## **Annexure 14:**

Responses to s92 requests prepared by MWM in  
respect of geochemical matters

**Document Number:** J-NZ0229-M-008-Rev0

**Document Title:** Response to S92(1): Consent Application Number RM24.184

Figure 1. Cu versus SO<sub>4</sub> for WRS seepage water quality

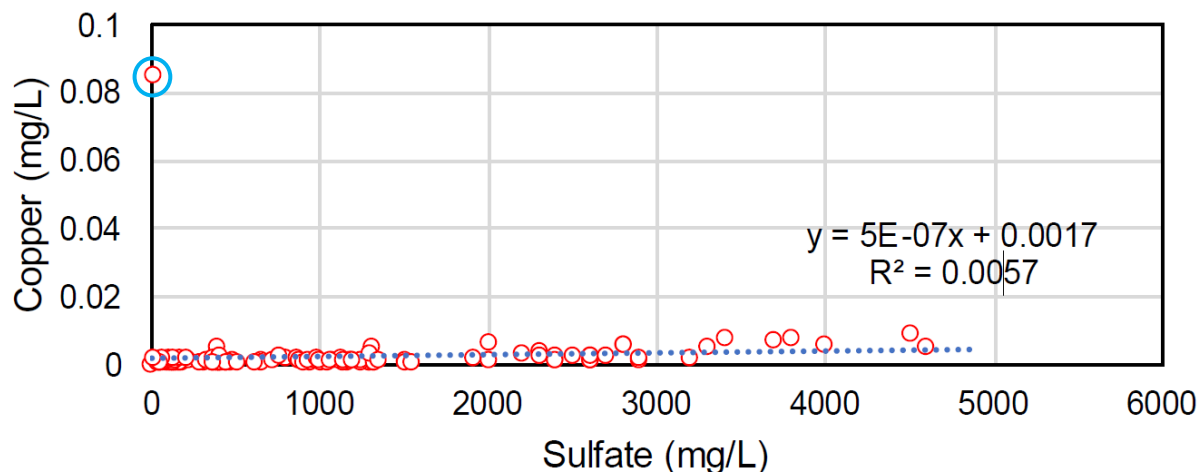
*“The water quality data contained in Appendix F suggests there is a high probability of copper causing significant adverse effects at MC02 and more than minor effects at NB03 during closure and after closure. To what extent does the current proposal contribute to long-term copper concentrations (i.e., what are the modelled concentrations under a scenario where the proposed activities do not occur)?”*

- Deepdell North Backfill water quality during 2001 – 2022 ranged from 0.0005 to 0.002 mg Cu/L (Table 7: MWM, 2024).
- Other pit lakes are shown in Table 21 (MWM, 2024) and ranged from 0.00057 - 0.001 mg Cu/L.
- Seepage water quality from waste rock stacks is shown in Table 25 (MWM, 2024) and ranges from an average of 0.0009 – 0.0041 mg/L with Cu being slightly higher when SO<sub>4</sub> is elevated (Figure 4, Appendix I: MWM, 2024), although the relationship is very weak (due to very low Cu values). These data are reproduced below in Figure 1 and show that generally higher values are seen for higher sulfate concentrations.

Note: there is one anomalous result (circled) that is likely to be an analytical / reporting / data entry error.

The water quality compliance limit for Cu is 0.009 mg/L in accordance with an assumed hardness of 100 mg CaCO<sub>3</sub>/L (i.e., conservative as hardness is generally higher in mine influenced waters at Macraes). Most data presented above is lower than this limit.
